2.0 Physical differences

3.0 Affected devices for BGA (Y)

Tray 50-9816

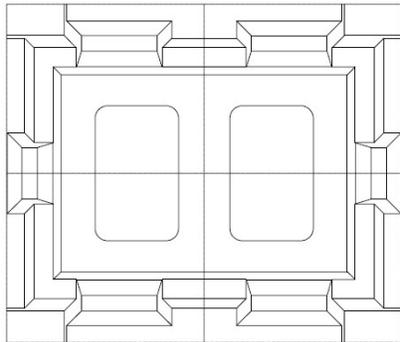
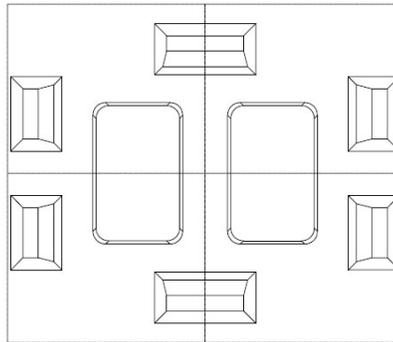
Tray 50-9816 solder ball at the perimeter corner of the unit will have high chance to knock into the tray wall during transportation when the units is rotated and tilted.

Tray 50-8000 (Top view different but bottom view is similar)

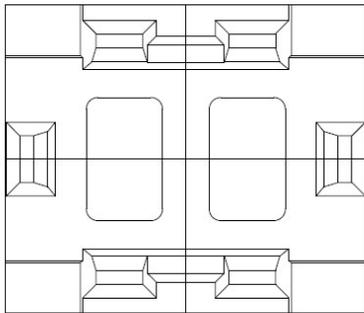
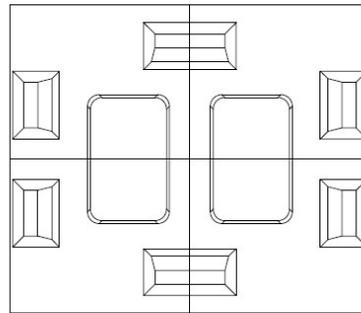
The tray 50-9816 and 50-8000 stackable with each other.

Both trays have silk screen printing indicating the tray part number, 8000 for 50-8000 and 9816 for 50-9816.

Tray 50-8000 solder ball at the perimeter of the unit will not hit any tray wall during transportation when the unit is rotated and tilted.
